Title: Addition of ESD Ground Stud

Product: RCP-MLTP2 (Desk Mount)

ECO No.: 3439

Figure 1. Ground Stud Location

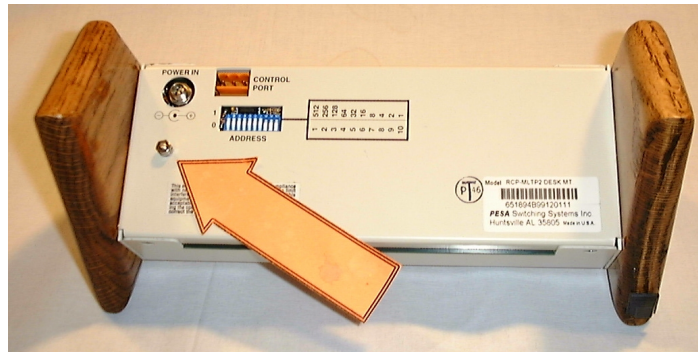
Issue:

To ensure compliance with EN61000-4-2 Electrostatic Discharge (ESD) Requirements, this product requires a chassis ground.

A #4-40 ground stud has been added to the rear panel as shown in Figure 1 below. The customer is responsible for providing the wire and terminal lug for use with this ground stud.

The ground wire should be installed in accordance with the ESD grounding standard applicable in the country of use.
